**Project #18-036
Denik Vooray Building
Located at 1200 West 2200 South**

Project Name: Denik Vooray Building
Proponent / Owner: Jon White / Jon and Darlene White Trust
Project Address: 1200 West 2200 South
Request: Design Review Permit
Current Zoning: Commercial (COM)
Type of Action: Quasi-Judicial
Hearing Date: Oct. 25, 2018
Submitted By: Russ Holley, Senior Planner

DENIK - VOORAY BUILDING
DESIGN REVIEW
SCALE: 1"=20'

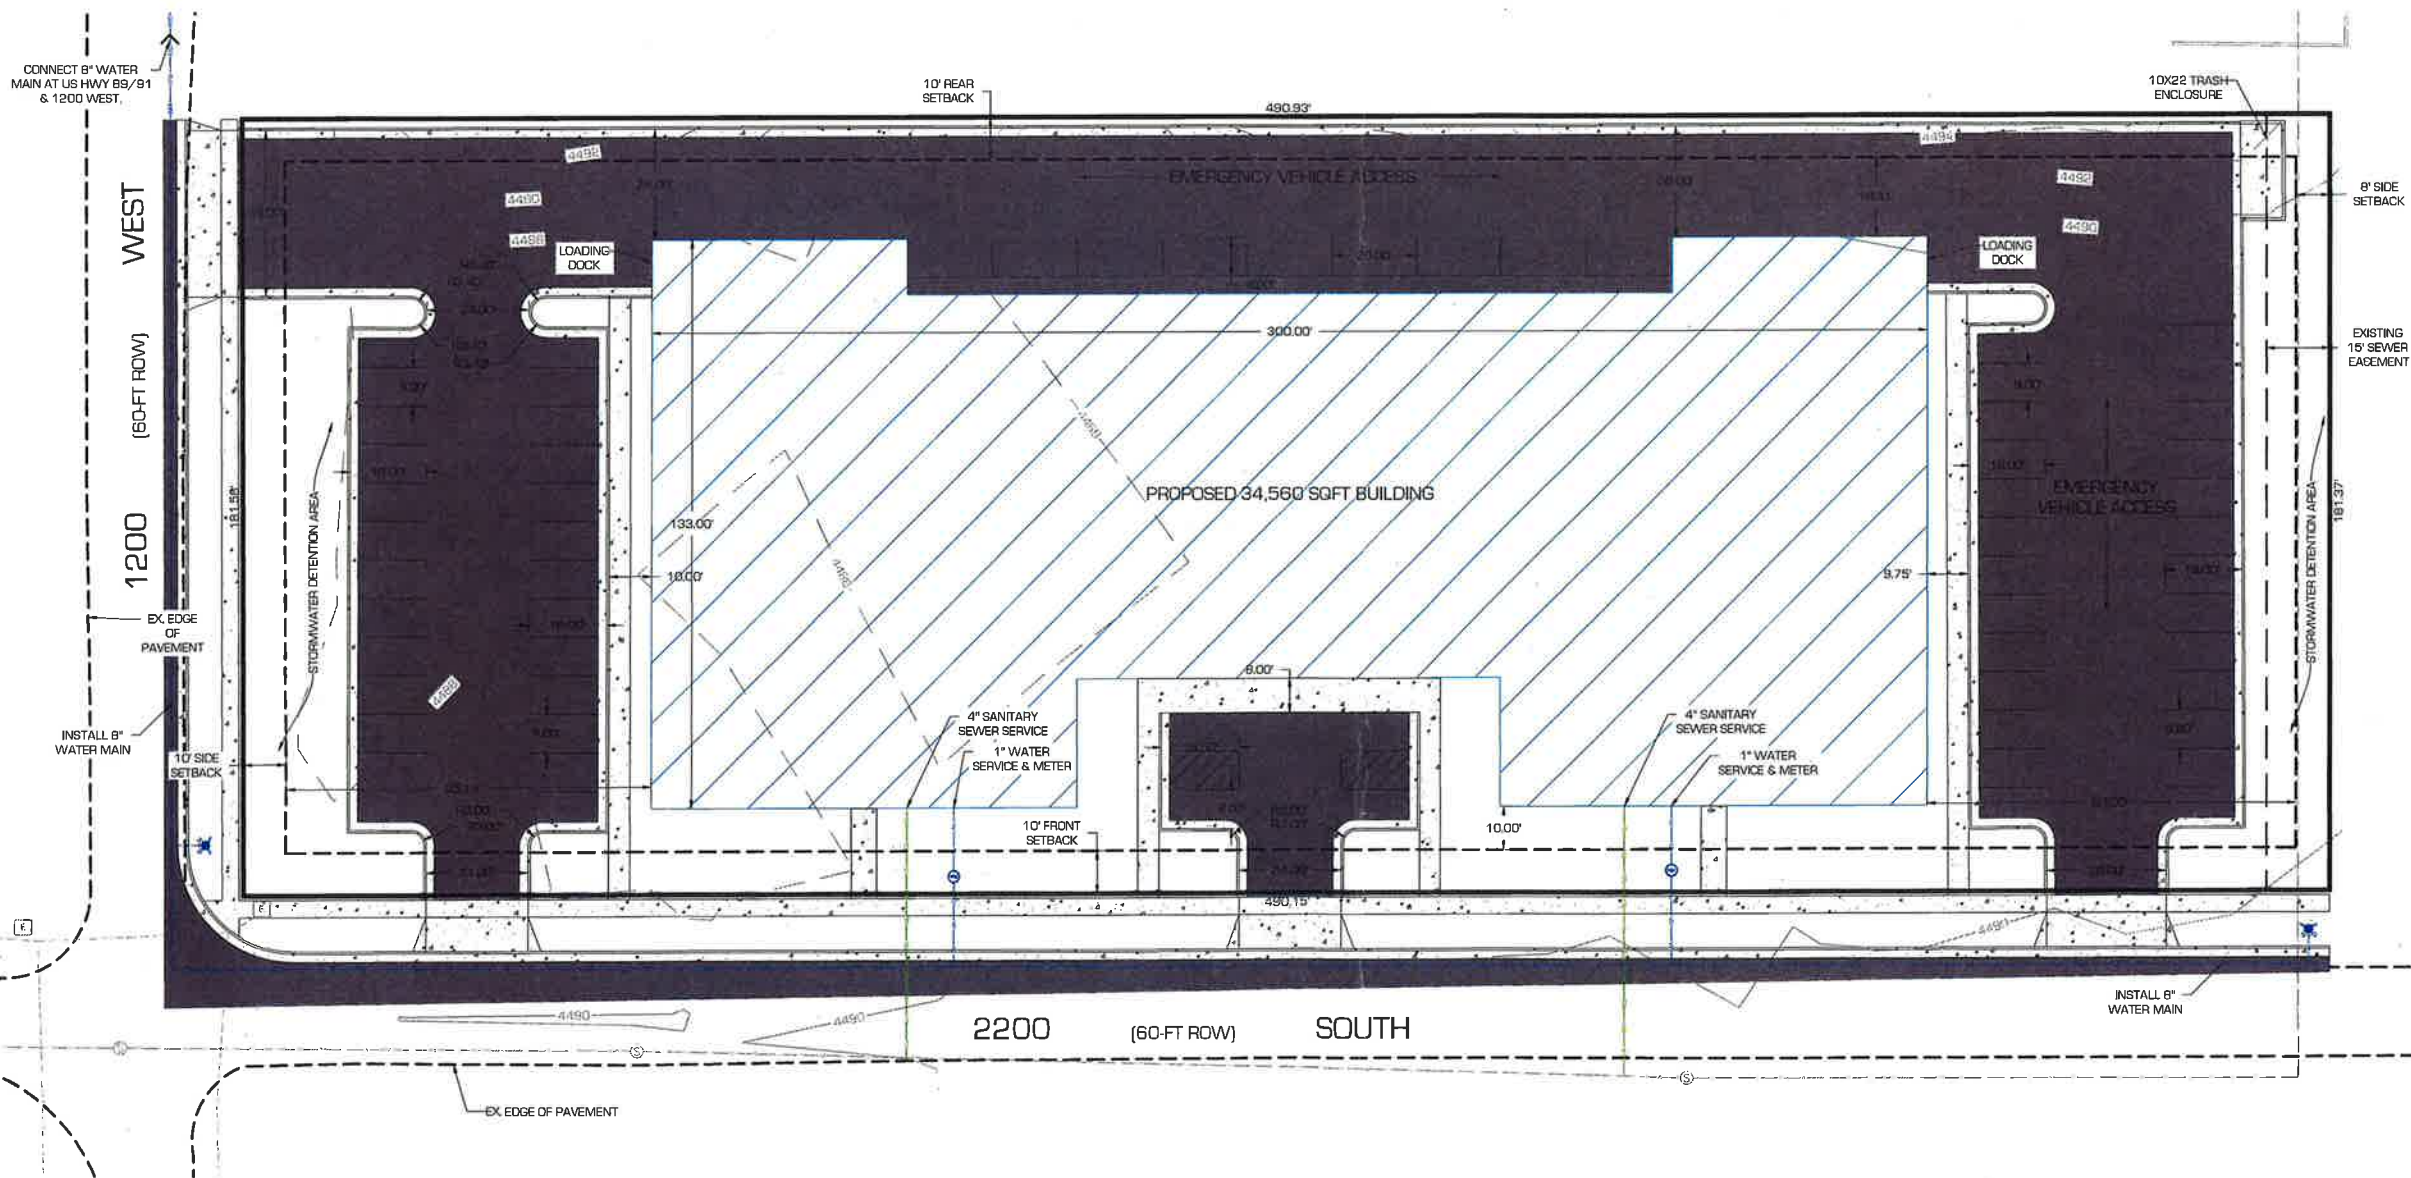
ornamental plants would be required as per the LDC. The submitted plan shows only conceptual landscaping areas. As conditioned with a detailed landscaping plan meeting minimum plant numbers, the project complies with the LDC.

The LDC 17.37.090 requires adequate lighting that adds aesthetic quality and improves safety while mitigating unnecessary glare, sky glow and light trespass. The LDC limits freestanding pole height to 32 feet and luminaire fixtures on buildings and canopies to be concealed source, down-cast and shielded from neighboring properties. Light measurements are required to range between 0.5 – 4.0 foot candles, so areas are sufficiently safe, but not excessively bright. As submitted, no exterior lighting has been shown. As conditioned, the project meets the requirements of the LDC.

- a. *Environmental—contact 716-9760*
 - Minimum inside measurement of a double enclosure is 22 ft. wide and 10 ft. deep. Place bollards in the rear and on the front corners of enclosure to protect walls. No gates required.

- b. *Engineering —contact 716-9160*
 - Provide water shares for new development per Utah Administrative Code R309-510-7.
 - City does not have any water mains in 2200 South. Development must extend water main down 1200 West from US 89 or must work out agreement to connect to private line in trailer court. Must verify fire flows and hydrant location per City fire marshal. Fire protection and services cannot be obtained from Nibley.

- Sewer flows must be verified and submitted for approval by both City and Nibley based on current capacity City has in the Nibley sewer line.
 - Storm water detention/retention must be provided per Logan City Standards. The 90% storm must be retained onsite and retained through the use of Low Impact Design methods.

- Dedicate right of way on 2200 South as needed to ensure a 66' right of way (33' from centerline of 2200 South).
 - Construct curb, gutter and sidewalk per City standards.

- Fire Sprinklers and Alarms Required. Fire hydrant within 100 ft. of FDC required.
 - Access
 - (IFC 503.1.1) Fire Apparatus Access shall extend to within 150 feet of all portions of the facility as measured by an approved route around the exterior of the building.

- Plan appears to have hard surface access on all sides of the building. Fire access roads shall be 20 ft. wide. Dead ends longer than 150 ft. shall be provided with a turn-around. Provide AutoCAD two track drawing indicating the following apparatus specifications on all fire access road and lanes: Inside turn 17 ft., Curb to Curb 32ft., and Wall to wall 36 ft.

- Need to provide exact accumulative square footage of fire areas (fire wall separations?) and type of construction.
- According to Table B105.1(2) the required fire flow for Type V construction at 34,560 sq. ft. is 5,000 gpm at 20 psi. (If fire sprinklers are installed this may be reduced)

- According to Table B105.1(2) the required fire flow for Type IIB construction at 34,560 sq. ft. is 4,000 gpm at 20 psi. (If fire sprinklers are installed this may be reduced)
Reduction 1,500 gpm

- There are no current hydrants or water mains in the area of the project. The 10 "main currently ends at approx. 2044 S Hwy 89/91
- According to the Logan City Engineering Fire Flow model:

- Fire Hydrant #FH proposed FH -1(see Map on fire flow memo) flows 2,255 gpm at 20 psi -s
- Fire Hydrant #FH proposed FH -2 (see Map on fire flow memo) flows 1,982 gpm at 20 psi

- Fire Hydrant Locations
- (IFC 507.5.1) Fire Hydrants shall be located within 400 feet of the building as measured by an approved route around the exterior of the building.

- Fire hydrants are required within 400 ft. of all areas of the building as measured around the perimeter of the building. If Fire Sprinklers are installed a hydrant is required within 100 ft. of the Fire Department Connection (FDC).

- Table C102.1 requires 5,000 gpm to be delivered from 5 accessible fire hydrants.
- Table C102.1 required that 4,000 gpm to be delivered from 4 accessible fire hydrants.

1. All standard conditions of approval will be recorded with the Design Review and are available in the Community Development Department.
2. The project shall provide 39 off-street parking stalls and a bike rack.

3. The project shall provide architectural wall breaks on the building every 30 linear feet as per the LDC standard.
4. The project shall provide 30% transparency along the south and west street facing facades.

5. All public pedestrian entrances shall have weather protection provided above.
6. Storm-water detention areas shall be placed outside of front and corner setbacks and visually screened with landscaping from view of public streets.

7. A performance landscaping plan, prepared in accordance with §17.39 of the LDC, shall be submitted for approval to the Community Development Department prior to the issuance of the building permit. The plan shall include the following:

- a) Street trees along all adjacent streets provided every thirty (30) feet on center unless otherwise noted by the City Forrester.
 - b) Open Space and Useable Outdoor areas shall total a minimum of 17,772 SF.

- c) A total number 40 trees and 102 shrubs, perennials and grasses shall be provided. 25% of the trees shall be evergreen.
8. All dumpsters shall be visually screened or buffered from public streets by using fencing, walls and landscaping.

9. Rooftop mechanical and/or building wall mechanical equipment shall be placed out of view from the street or screen from view from the street.
10. Exterior lighting shall be concealed source, down-cast and shall not illuminate or cast light onto adjacent properties.
